Saab Original Parts Information Update

PI-number: 16-08-19

Universal joint for CV 9-3 MY99-03

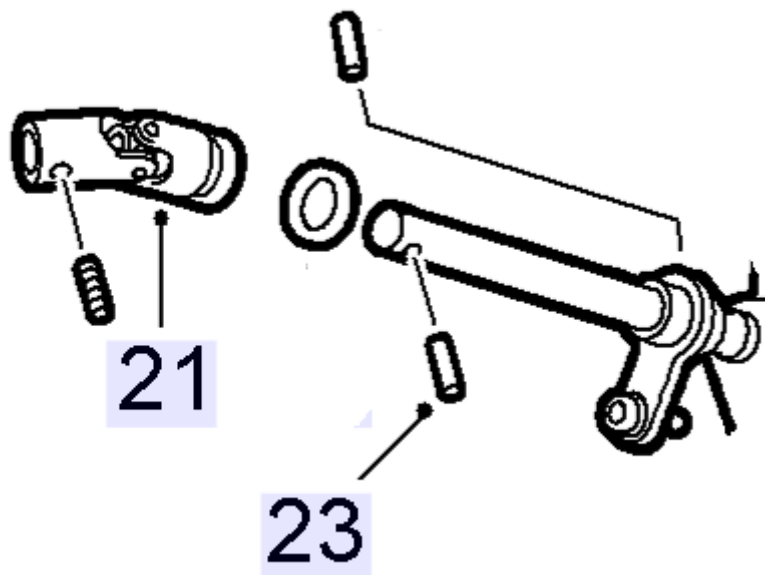
To be able to mount universal joint 5362728 (pos21), a hole shall be drilled (4mm) for the safety pin (pos23).
